**THE COUNCIL OF THE CITY OF
COVENTRY (CITY CENTRE SOUTH)
COMPULSORY PURCHASE ORDER 2022**

**REBUTTAL PROOF OF EVIDENCE OF
ALEC PHILPOTT IN RESPECT OF
SERVICING**

JANUARY 2023

Job code:	RLAMCorporationSt.1
Prepared by:	Alec Philpott
Issue Date:	12th January 2023
Status:	FINAL

Figure 2.1: Block B to Block A2 Pedestrian Route

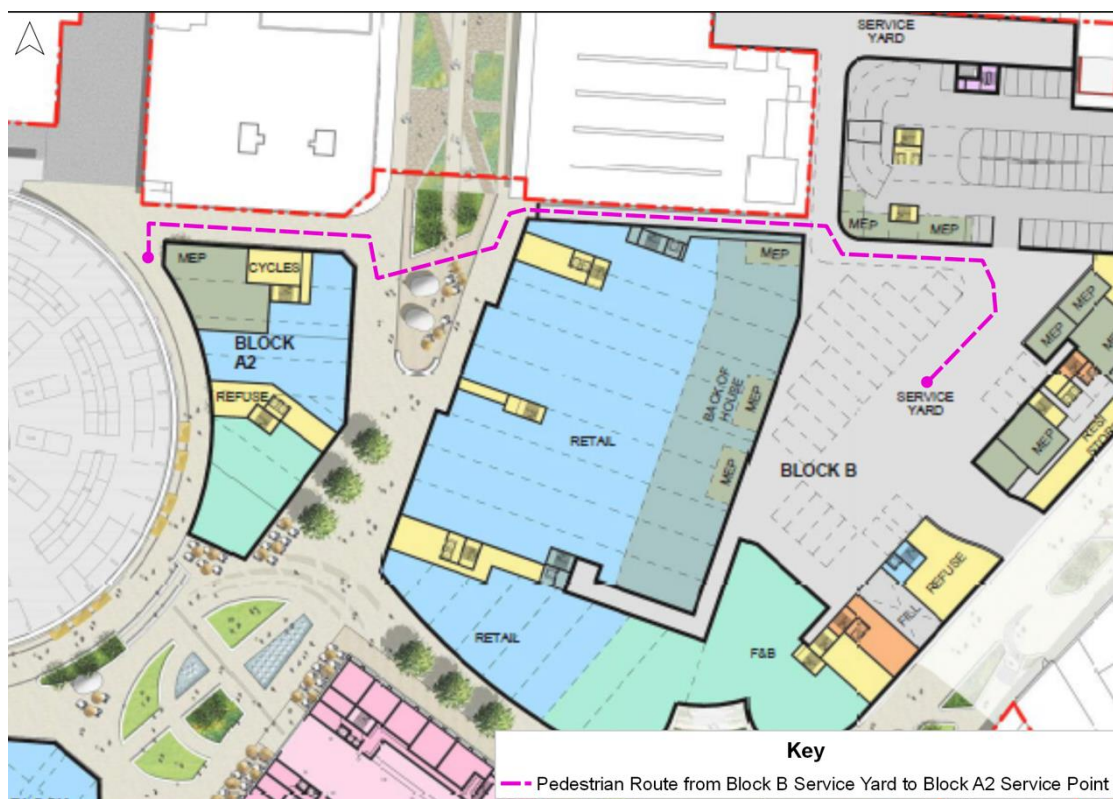
- 2.6 At paragraph 3.33 of RV's evidence (PDF page 11) Mr Vaughan suggests that Block A2 could also be serviced from the Block B service yard, which lies to the east of Block A2 and behind Block B.
- 2.7 It is assumed that RV expects delivery drivers to walk deliveries from the Block B yard to Block A2, as illustrated in Figure 2.1 below.

- 2.8 The illustrated route is some 197m long which equates to a walk time of five minutes (two way), assuming a reasonable walking speed of 80m/minute.
- 2.9 Block B Service Yard is plainly disconnected from Block A2 and the route between the two is tortuous and long, with no obvious relationship between the two for servicing.
- 2.10 RV has offered no tangible way to manage the servicing demand for Block A2 from two separate yards.
- 2.11 In the absence of appropriate management it is my opinion that, in practice, delivery drivers will naturally try and get their delivery vehicle as close to Block A2 as possible.
- 2.12 Therefore, it is my opinion that there should be no reliance placed on the use of Block B service yard to facilitate servicing of Block A2.

- 2.13 Consequently, Block A2 should be provided with a dedicated yard which accommodates at least 4 service bays.

Figure 2.3: TPP Revised Block A2 (Yard C) – Additional Vehicle Manoeuvre

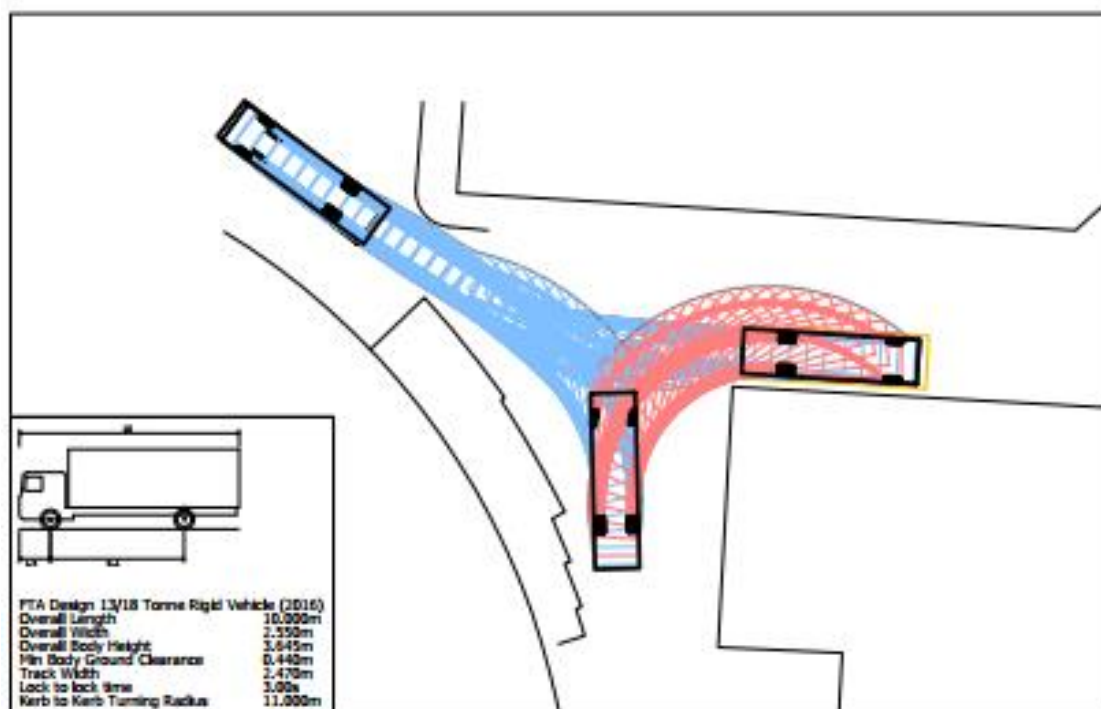
- 2.22 This demonstrates that in order to enter, or exit, the bay a service vehicle will need to reverse in an area which is heavily trafficked by pedestrians passing between Coventry Market and Market Way as identified on Figure 5.3 of my main evidence.
- 2.23 In addition, the tracking provided by TPP (illustrated in Figure 2.3 above) conflicts with areas used by Market Traders for their stalls, as well as conflicting with those customers visiting the stalls as illustrated in the photograph below.

Figure 2.5: Market Stalls/A2 Tracking Overlay

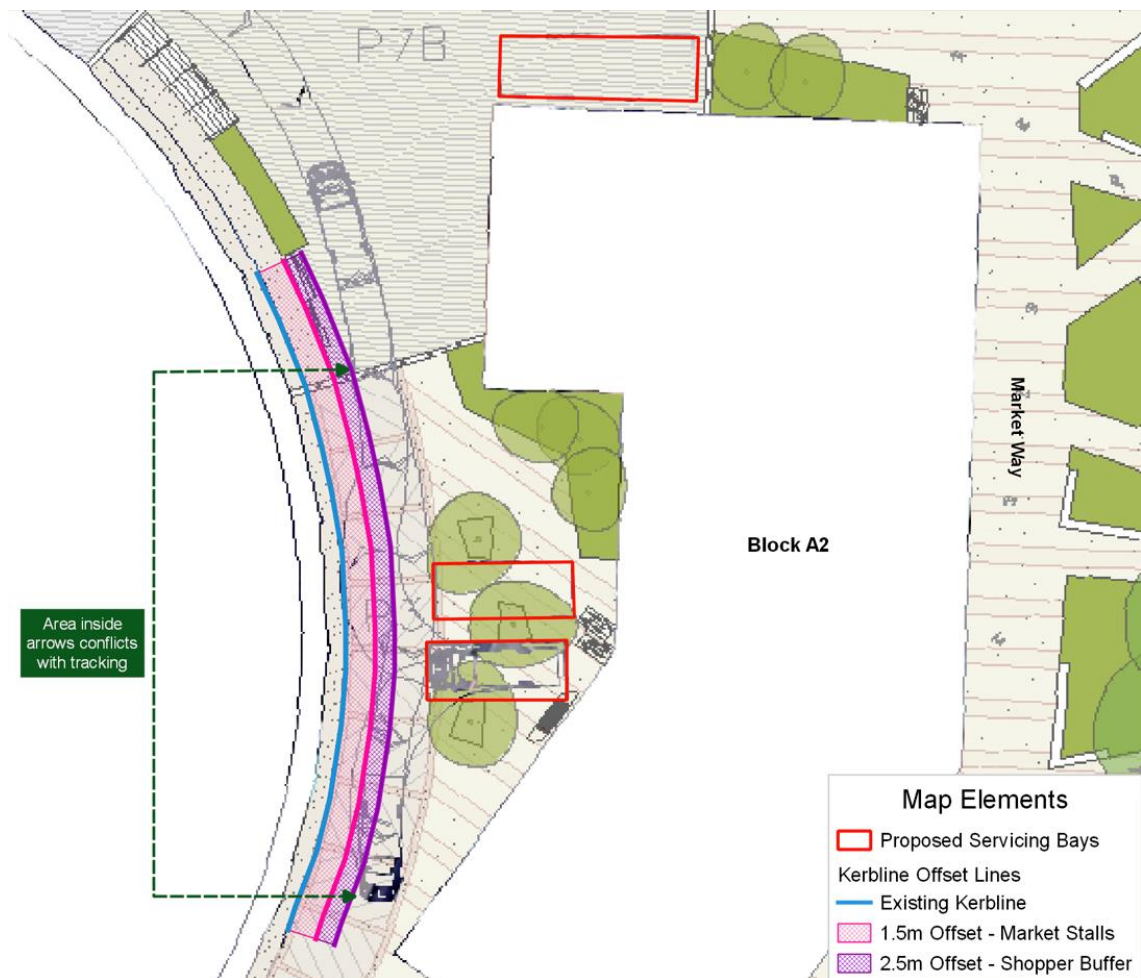
- 2.25 It is clear from Figure 2.5 that the manoeuvres required to access the revised loading bays conflict with the market stalls and associated area occupied by shoppers. Consequently, the proposed revised servicing strategy for Block A2 is not achievable.
- 2.26 As set out in the Mayer Brown November 2022 Technical Note appended to RV's proof of evidence (para 1.30, PDF page 69 of RV's proof) *"It is considered that servicing adjacent to Block A2 needs to be relocated elsewhere or Block A2 reconfigured to provide a loading area of adequate size, where it does not conflict with key pedestrian desire lines"*
- 2.27 It is my opinion that the servicing arrangement presented for Block A2 in RV's proof has not minimised impacts on pedestrian routes and is unsafe given the risk posed to pedestrians.

Figure 3.1: Vehicle Tracking of New Service Yard (Block A1)

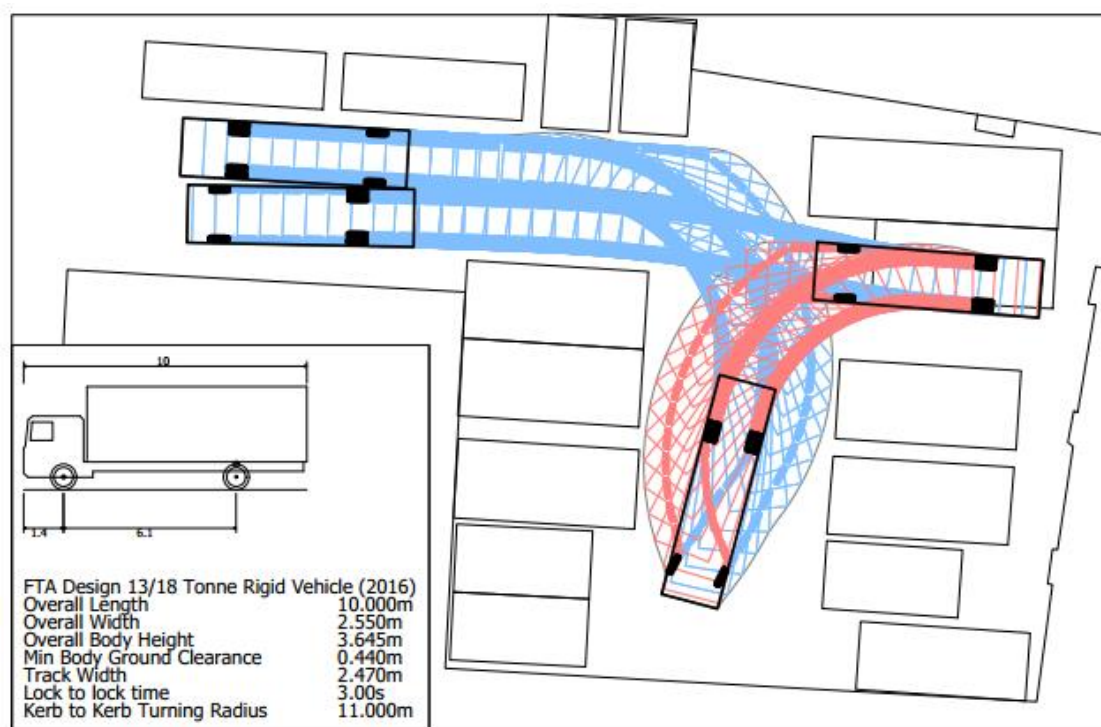
- 3.13 The proposed layout of the yard is such that it does not provide adequate turning for a service vehicle, should one arrive and all loading bays be occupied.

- 3.14 Figure 3.1 below demonstrates the space required for a vehicle to turn, which necessitates the removal of one of the proposed loading bays. Without the removal of this bay, HGV's would be required to reverse into Queen Victoria Road which would be unsafe.

- 3.15 Notwithstanding the next section of my rebuttal, the proposed revisions are inadequate to cater for expected demand and do not provide sufficient space for manoeuvring.
- 3.16 The revisions therefore do not resolve the deficiencies of the scheme that are set out in my main proof.

Figure 4.1: Extract of Royal London Leasehold Boundary

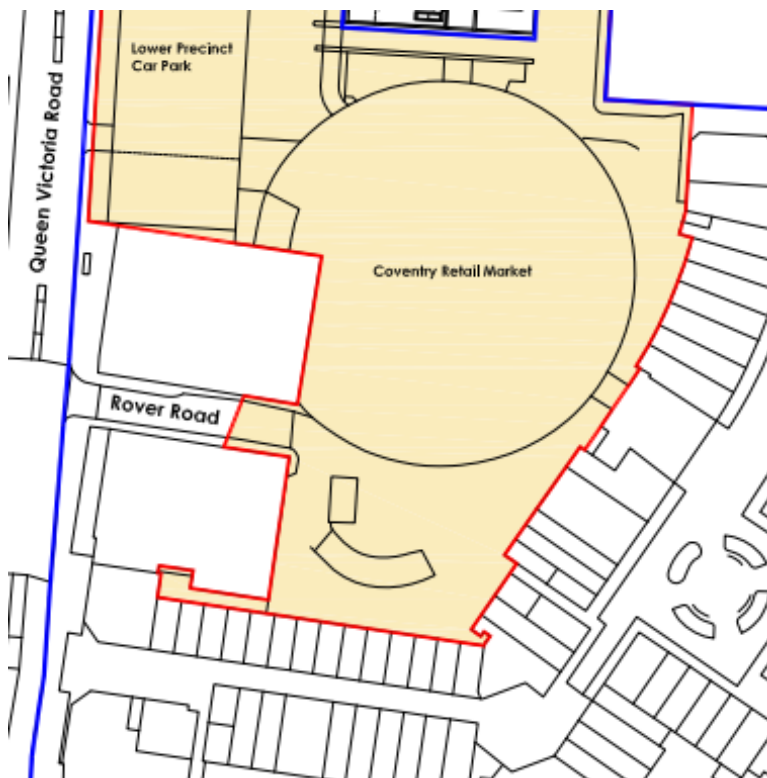
- 4.1 This section of my rebuttal should also be read as representations on the Stopping Up Order Inquiry, to be considered in parallel with the CPO Inquiry and should be read alongside submissions made to the National Casework Team by RPS dated 22nd December 2022, appended hereto.
- 4.2 Figure 4.1 below illustrates the extents of the Royal London Leasehold in the vicinity of Rover Road.

- 4.4 It is clear from the above that in order to access Royal London's leasehold area, Market Traders require the right to pass over the area to be stopped up.

Figure 4.2: Area to be Stopped Up (Rover Road)

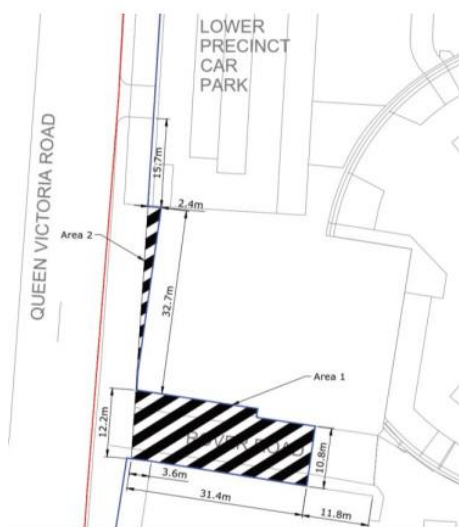
- 4.5 The same is also true for pedestrians accessing Coventry Market from Queen Victoria Road.
- 4.6 The key issue for Royal London is a matter of timing of the making of any order. Once made, the owner of the land has the right to prohibit access and has the ability to landlock the Market.

- 4.8 To date, neither of the above have been provided and consequently it is not considered acceptable to make the order to stop up Rover Road as it could prejudice the operation of Coventry Market and would deprive the objector of access rights.

- 4.7 In order to remove Royal London's objection relating to the stopping up of Rover Road, Royal London would need one of the following to be provided:

- An adequate alternative access for pedestrians and service vehicles to be provided before the land is stopped up, which must be agreed with Royal London; or

- A grant of rights in appropriate form, and giving sufficient assurance that the rights will be maintained, should be granted to Royal London, its tenants and the public to pass over the area to be stopped up, until such a time as an adequate alternative is provided, which must be agreed with Royal London.
